# METROPOLITAN GOVERNMENT OF NASHVILLE AND DAVIDSON COUNTY

Metropolitan Historic Zoning Commission  
Sunnyside in Sevier Park  
3000 Granny White Pike  
Nashville, Tennessee 37204  
Telephone: (615) 862-7970  
Fax: (615) 862-7974

## STAFF RECOMMENDATION 2001 18<sup>th</sup> Avenue South December 19, 2012

**Application:** New construction - addition  
**District:** Belmont-Hillsboro Neighborhood Conservation Zoning Overlay  
**Council District:** 18  
**Map and Parcel Number:** 10412021900  
**Applicant:** Michael Ward, Architect  
**Project Lead:** Sean Alexander, sean.alexander@nashville.gov

**1** Site Plan  
 Scale: 1/16"=1'-0"

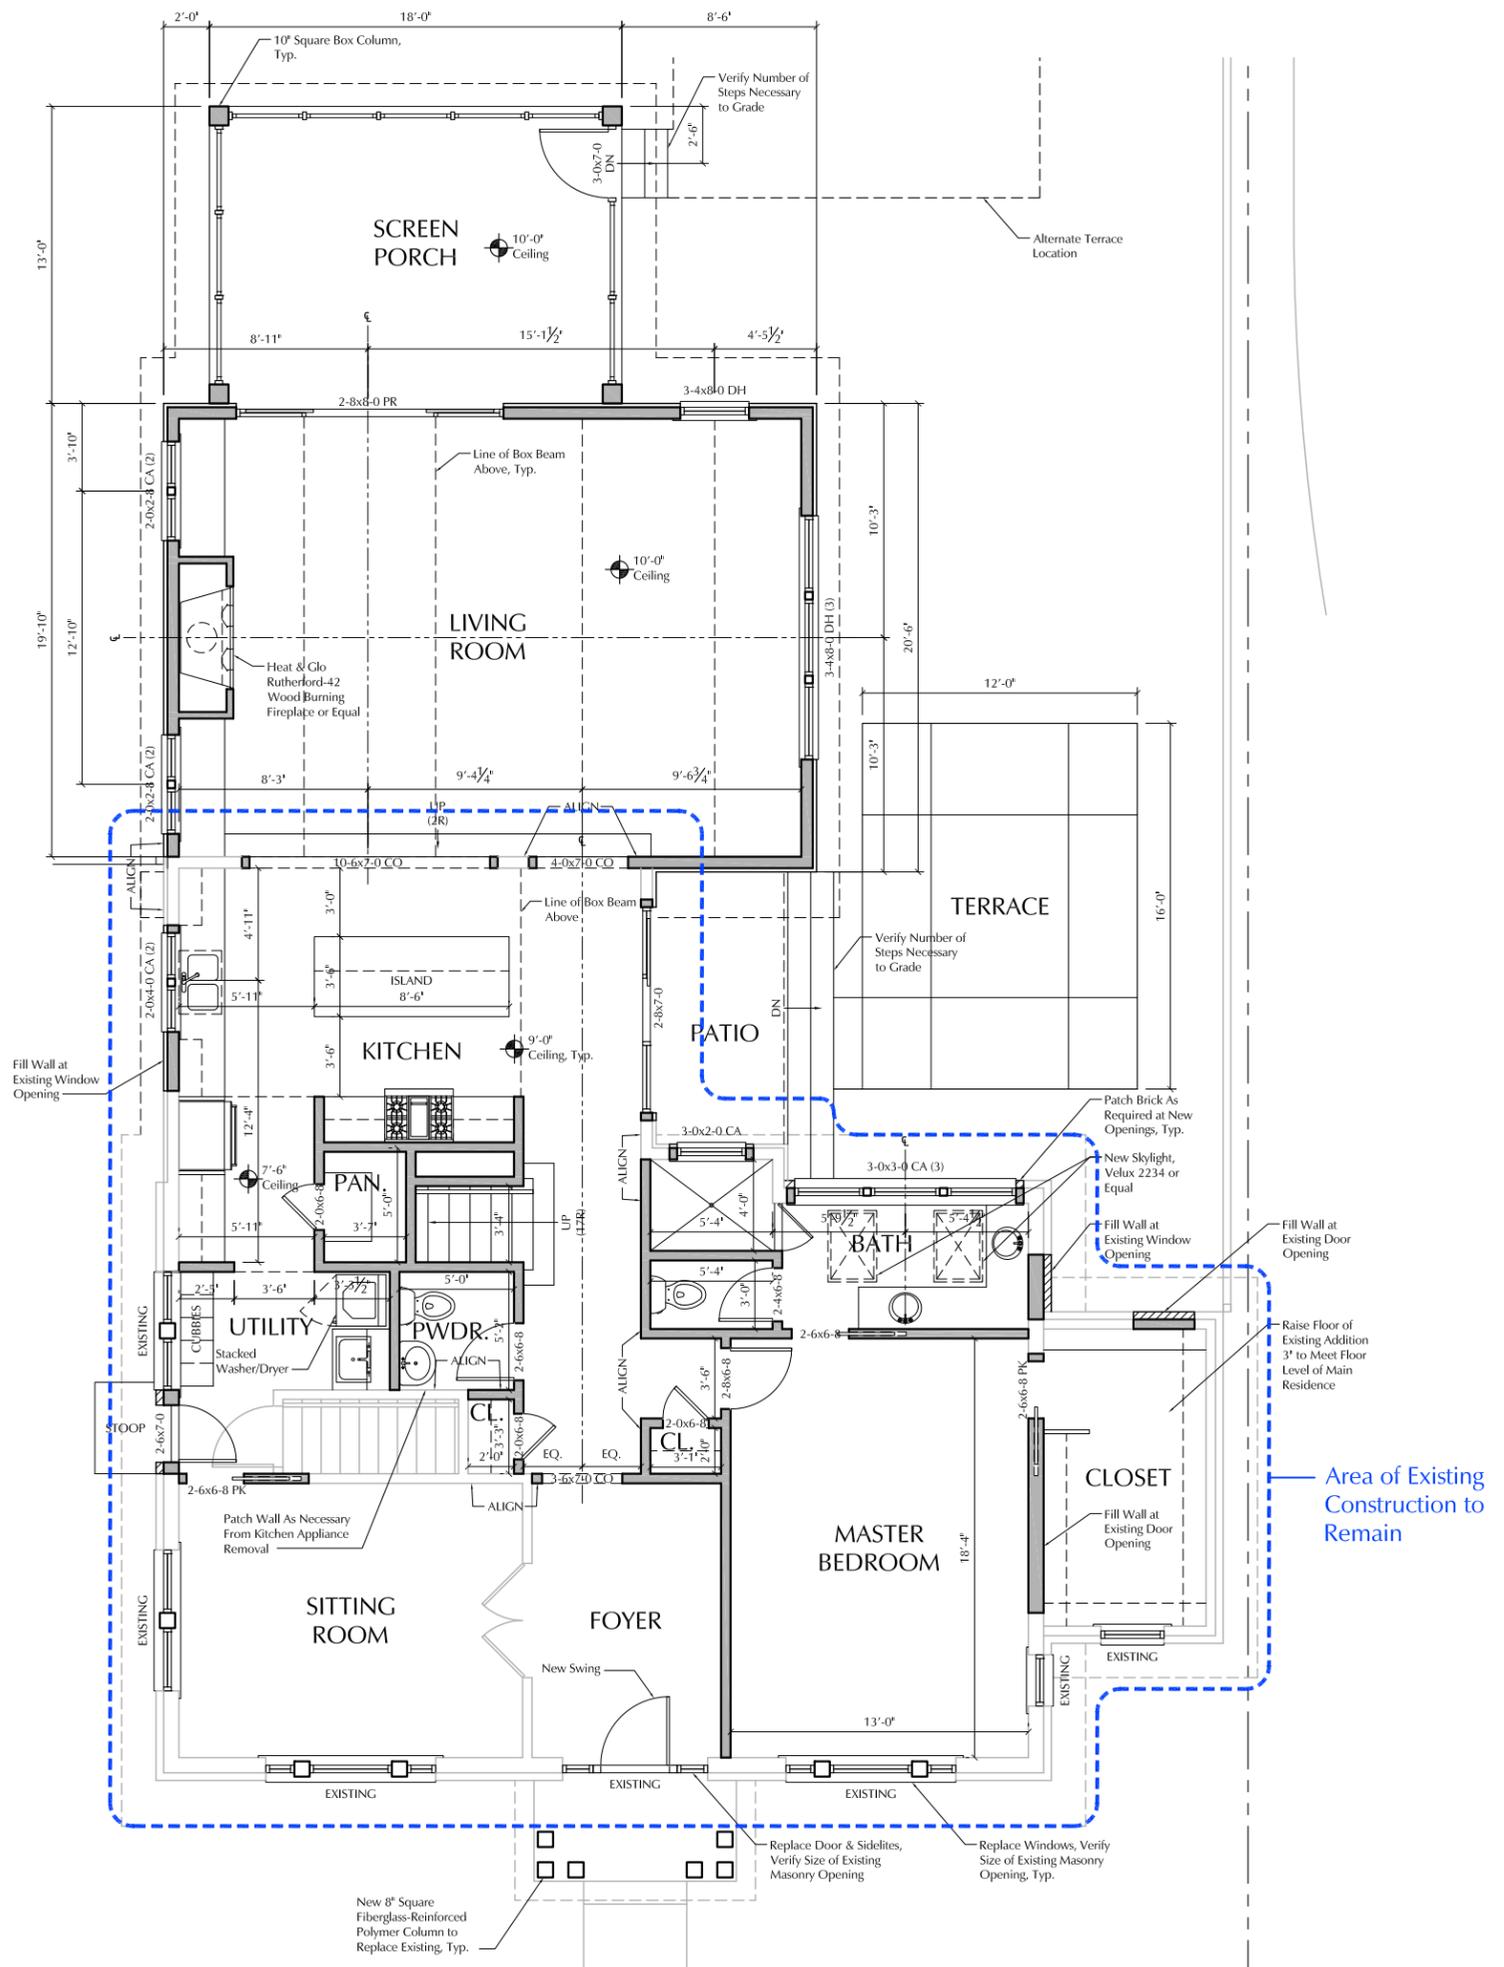
The addition will set in from the right side of the house, along Portland Avenue, by more than fifteen feet (15'). On the left side the addition will extend the wall of an existing addition that does not set in. Typically additions are required to set in on both sides of an historic house to distinguish it from a historic structure, but because the condition is existing and the addition will have a different exterior material than the historic house, staff finds the current proposal to meet guidelines II.B.1.b and II.B.2.a.

The addition will meet the required setbacks by maintaining the eight foot (8') left setback and by being eighteen feet (18') from the right property line. These setbacks are also consistent with the setbacks of other historic houses. The footprint of the existing house is one thousand, five hundred square feet (1,500 sq. ft.) in area, leaving roughly eighty percent (80%) of the lot open. Nearby houses have similar amount of open space, varying from sixty-five to eighty percent (67%-80%) open space. With the addition increasing the footprint by eight hundred square feet (800 sq. ft.), there will be roughly seventy-one percent (71%) open space remaining, which is within the range found on nearby lots. Additionally, there is a forty foot (40') wide public side-lot between the property line and Portland Avenue, which helps to reduce the perceived massing of the addition. Under these circumstances, and because the massing of the addition is shifted toward the interior of the lot, Staff finds the mass of the addition in relation to open spaces to meet guidelines II.B.1.b.and II.B.1.c.

1 South Elevation  
 Scale: 1/8"=1'-0"

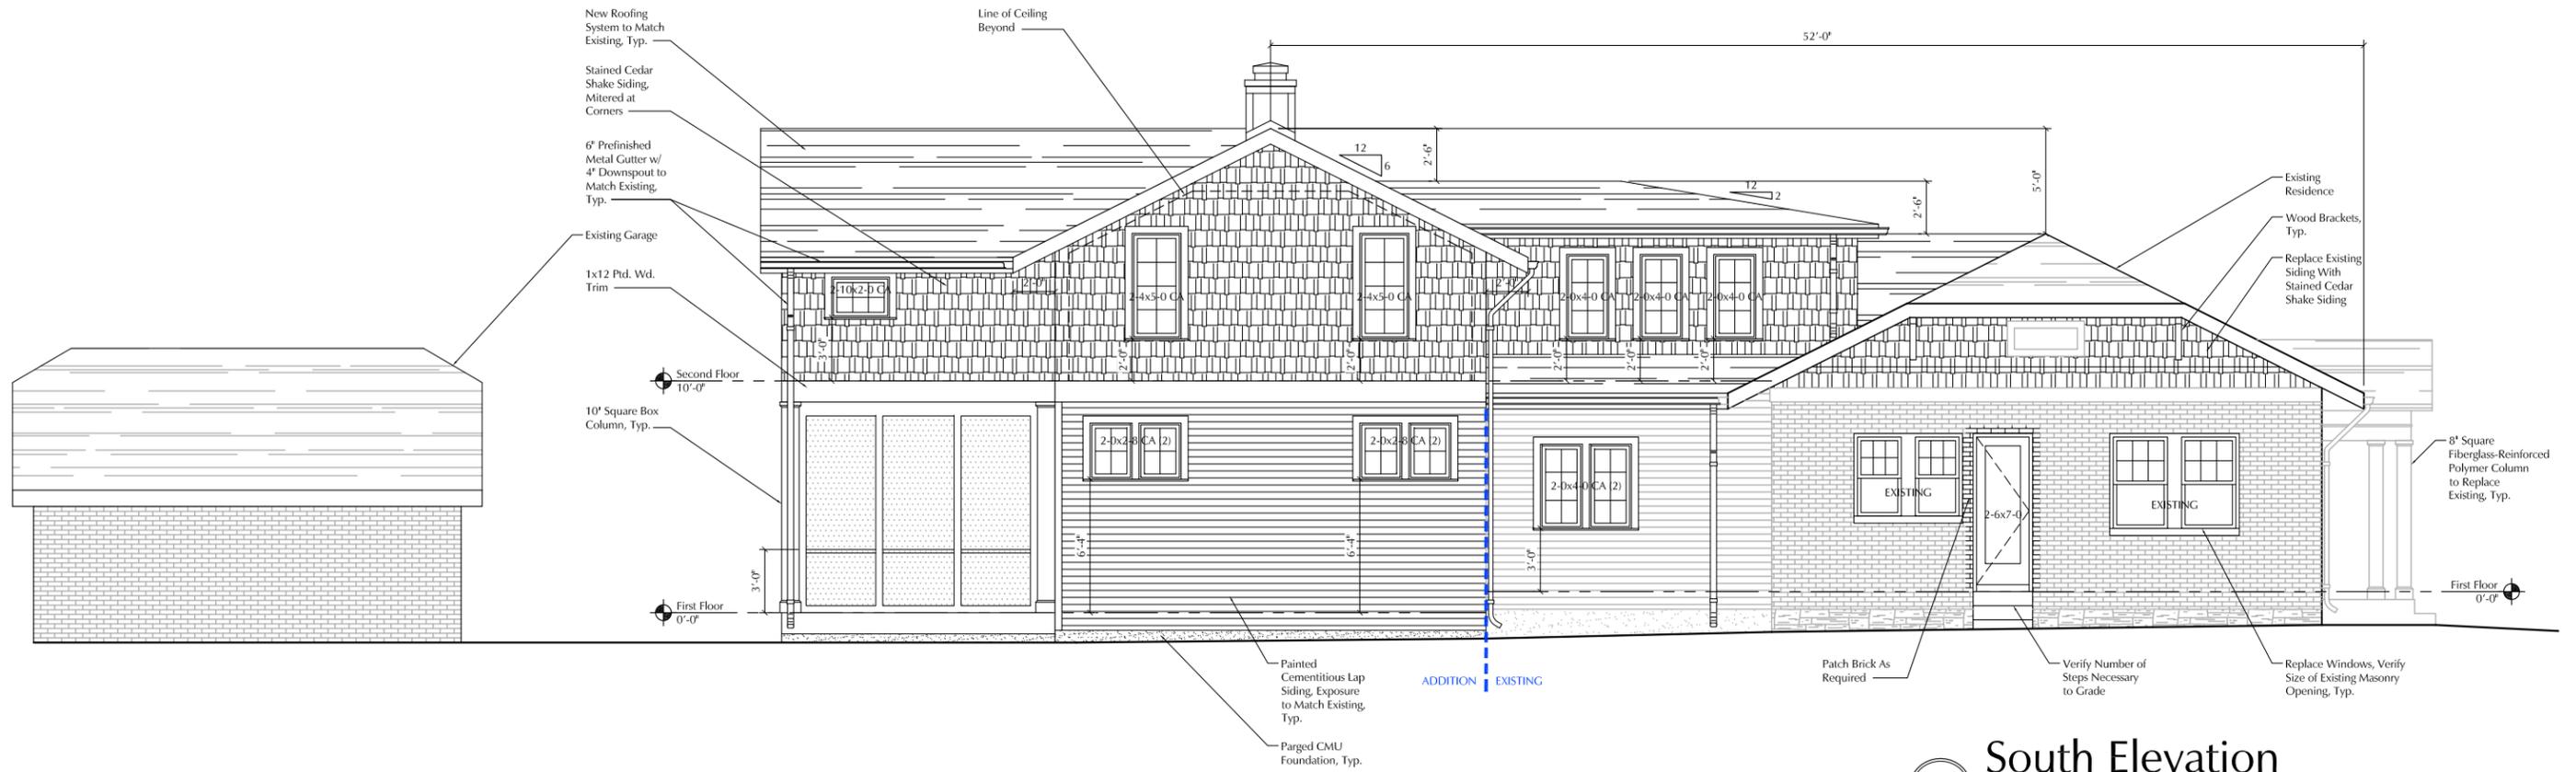
The rear addition will be taller than the existing house, with a side-gabled roof five feet (5') higher than the ridge of the existing roof. The higher ridge will be fifty feet (50') behind the front of the house, and will comply with the Commission's policy that additions taller than existing houses are appropriate when they rise only one foot (1') in height for each ten feet (10') in length and that the addition not also be wider than the house. Because the addition meets those criteria, and because the roof will be hipped on the more visible north elevation helping to reduce the perceived height, staff finds the addition to meet guideline II.B.1.a.

Both the left and right elevations will have window patterns that maintain the rhythm and proportion of the windows on the existing house, which meets guideline II.B.1.g. The windows on both stories are vertically oriented, and taller on the first story than the second. Staff finds the window rhythm and proportion to meet guideline II.B.1.g.

2 North Elevation  
 Scale: 1/8"=1'-0"

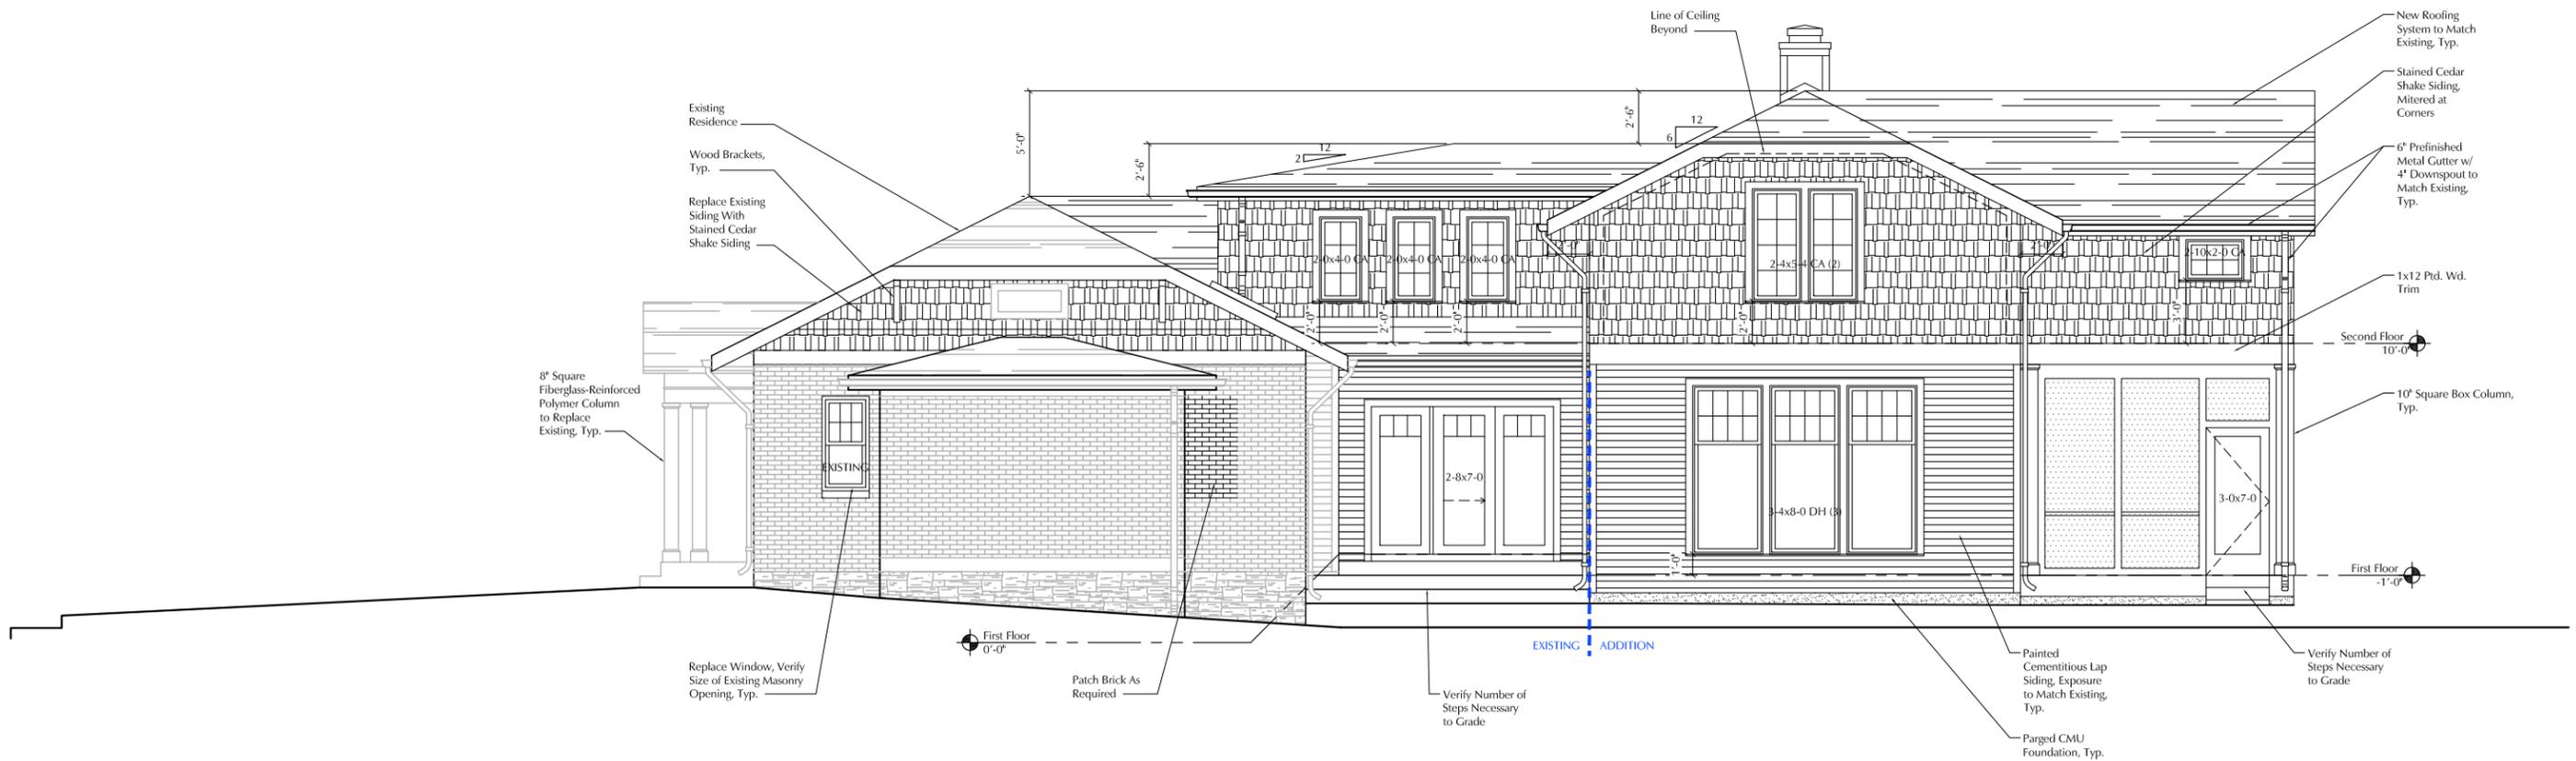
The primary roof of the addition will be a 6:12 gable, clipped on the more visible north end. The form and pitch match the existing roof. Between the primary roofs of the historic house and the addition will be a low-pitched hipped roof “hyphen.” Because of the low pitch and because the walls are set in an additional two feet (2’) from the first story walls on each side, the eaves and roof of this hyphen will not be greatly visible. Staff finds the roofs to meet guideline II.B.1.e.
